# SERVICE BULLETIN

**Service Bulletin No.:** DAC1-27-01 Rev 0

**Title:** Optional Stick Mounted Trim Switch Installation

Figure 1

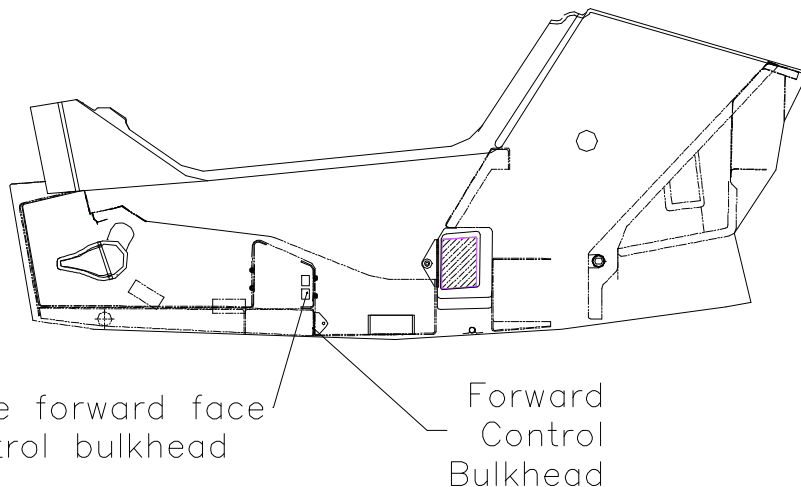
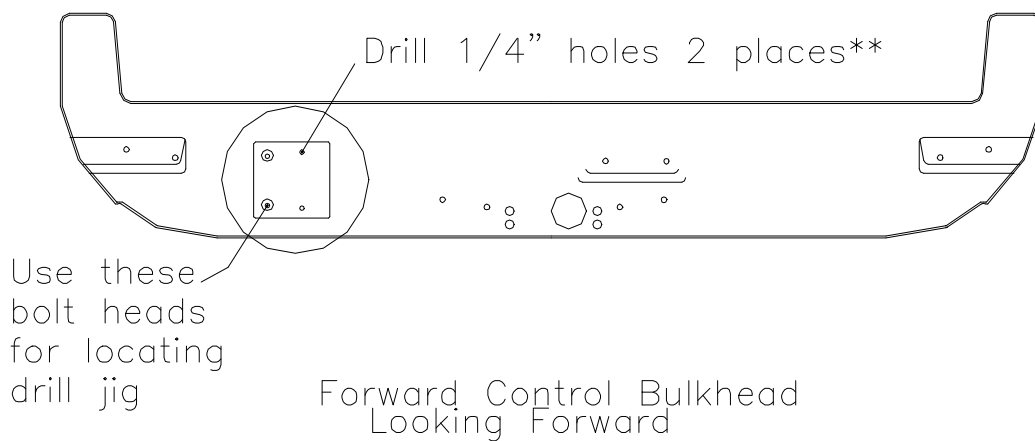
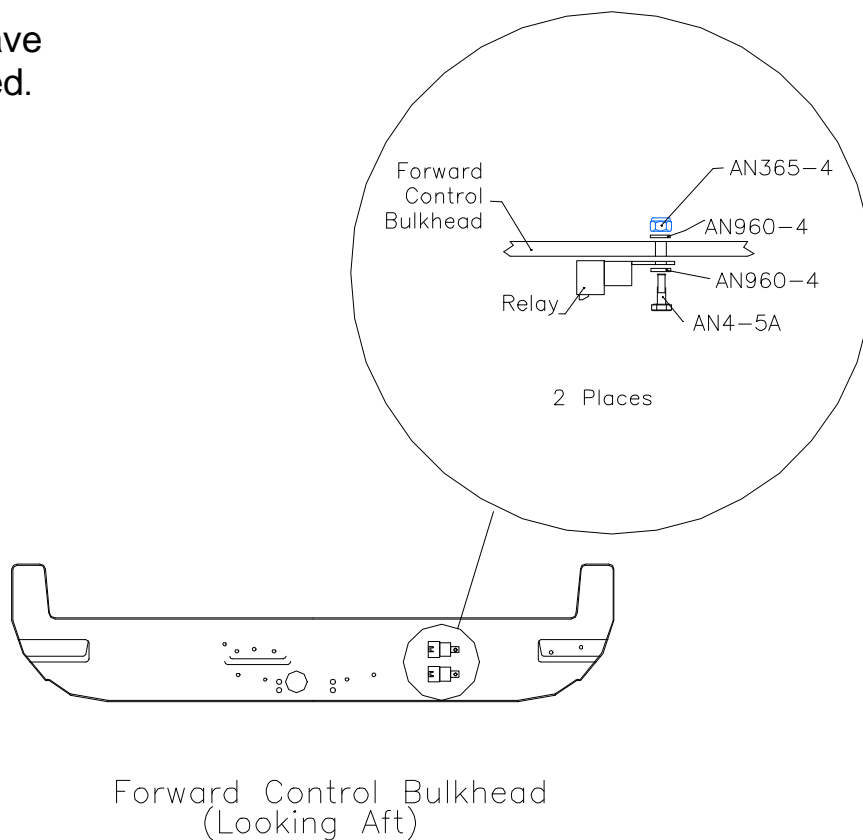
- 10.6** If the aircraft is equipped with the optional recognition lights proceed to step 10.9.
- 10.7** On the forward control bulkhead (the bulkhead aft of the control sticks) locate the drill jig onto the heads of the bolts. Mark the location for drilling the relay mounting holes. The drill jig has 6 holes drill the 2 holes closest to the heads of the locating bolts. Reference Figure 1 for this procedure.

- 10.8** Drill two 1/4" holes for mounting of the trim switch relays. Reference figure 1.
- 10.9** Install the relays on the forward side of bulkhead as shown in figure 1. If the aircraft has recognition lights installed these relays are installed using the existing pulselight power supply mounting bolts in the locations shown in figure 1.

Mount relays on the forward face  
of the forward control bulkhead

Figure 2

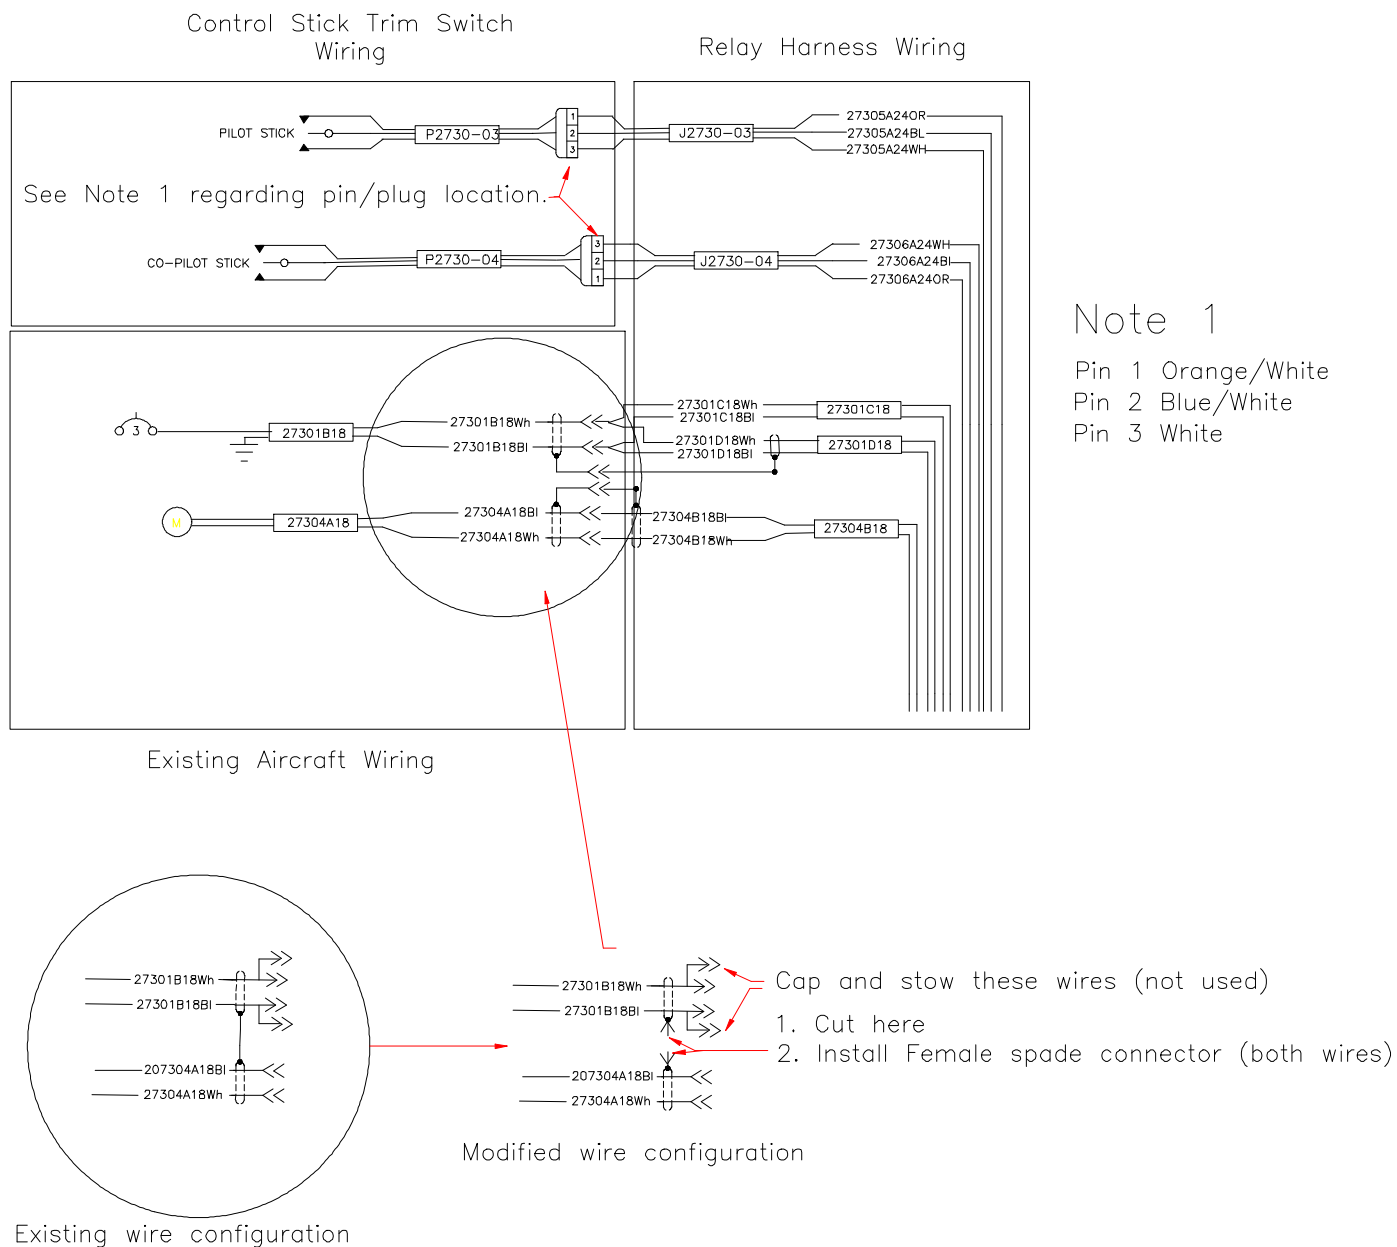
- 10.10** Reconfigure the removed trim switch wiring as shown in figure 2.
- 10.11** Connect the PTT and trim switch wiring from both control sticks as shown in figure 2.

- 10.12** Connect the relay harness as shown in figure 2.
- 10.13** A schematic diagram of the complete wiring is shown in figure 3 for reference.
- 10.14** Secure the wiring as necessary. Ensure that wiring does not become too tight when operating the flight controls about their full range.
